# HISTORIC AND DESIGN REVIEW COMMISSION

**HDRC CASE NO:** 2023-164  
**ADDRESS:** 118 MAY  
**LEGAL DESCRIPTION:** NCB 1373 BLK 1 LOT N 74.33 FT OF 25  
**ZONING:** RM-4, H  
**CITY COUNCIL DIST.:** 2  
**DISTRICT:** Dignowity Hill Historic District  
**APPLICANT:** Adriana Ziga/Ziga Architecture Studio, PLLC Bob Prado/  
**OWNER:** Delafield Investment, LLC  
**TYPE OF WORK:** Construction of a 2-story, single family residential structure  
**APPLICATION RECEIVED:** April 27, 2023  
**60-DAY REVIEW:** Not applicable due to City Council Emergency Orders  
**CASE MANAGER:** Edward Hall

## REQUEST:

The applicant is requesting a Certificate of Appropriateness for approval to construct a 2-story, single-family residential structure at 118 May, located within the Dignowity Hill Historic District.

PROPOSED EXTERIOR  
ELEVATIONS

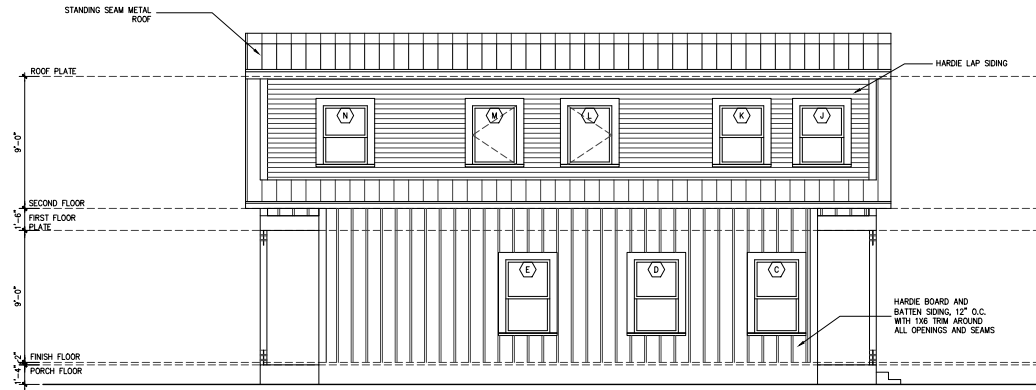
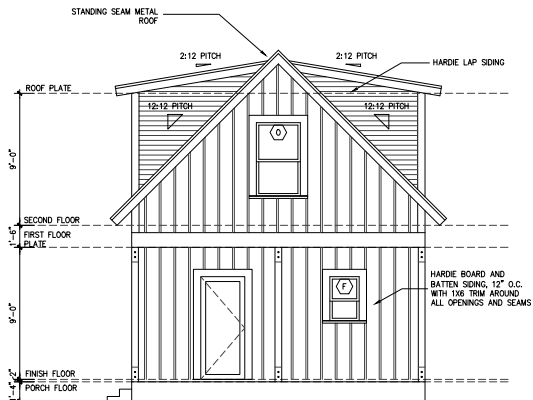
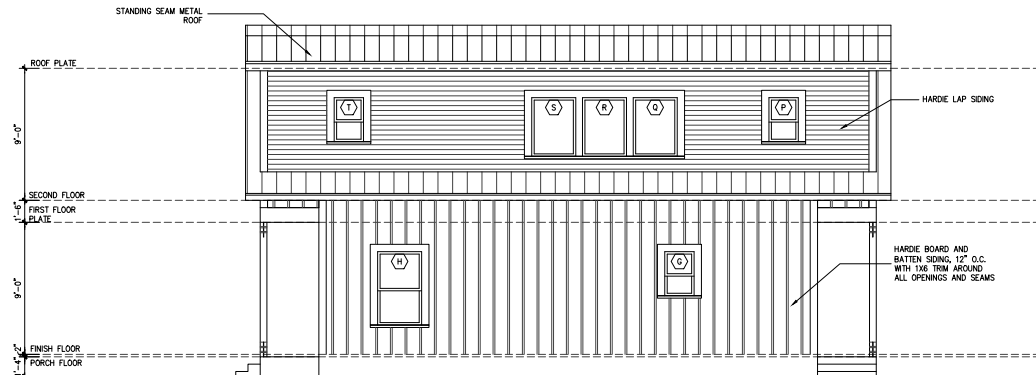
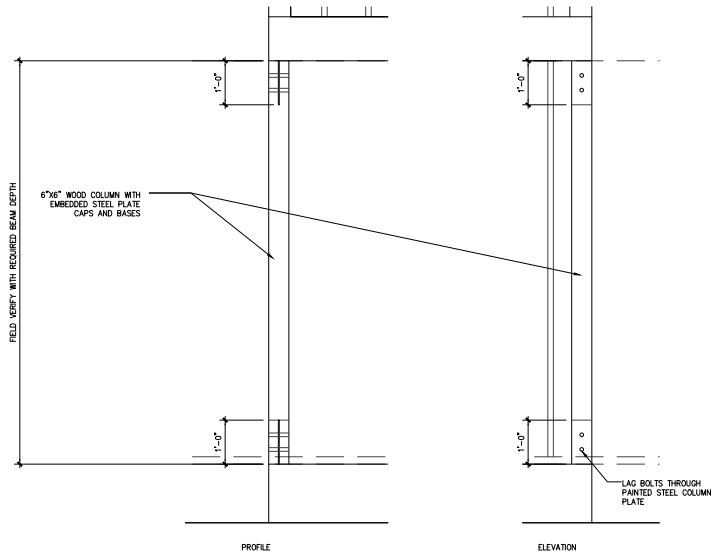
- k. FENESTRATION PROFILE – The applicant has proposed a number of window profiles that are consistent with examples found historically within the district; however, on the side profile of the proposed east dormer, the applicant has proposed window profiles that feature single-sash, fixed windows and single-sash casement windows. Staff finds that all proposed windows should feature profiles that are found historically within the Dignowity Hill Historic District, and that all windows should adhere to the adopted policy guide for windows in new construction. Windows should feature a one over one profile.

- m. ARCHITECTURAL DETAILS – Generally, staff finds the proposed architectural details to be appropriate; however, as noted in finding k, staff finds that window profiles should be modified to be consistent with those found historically within the district. Windows should feature one over one profiles.

Staff recommends approval based on findings a through q with the following stipulations:
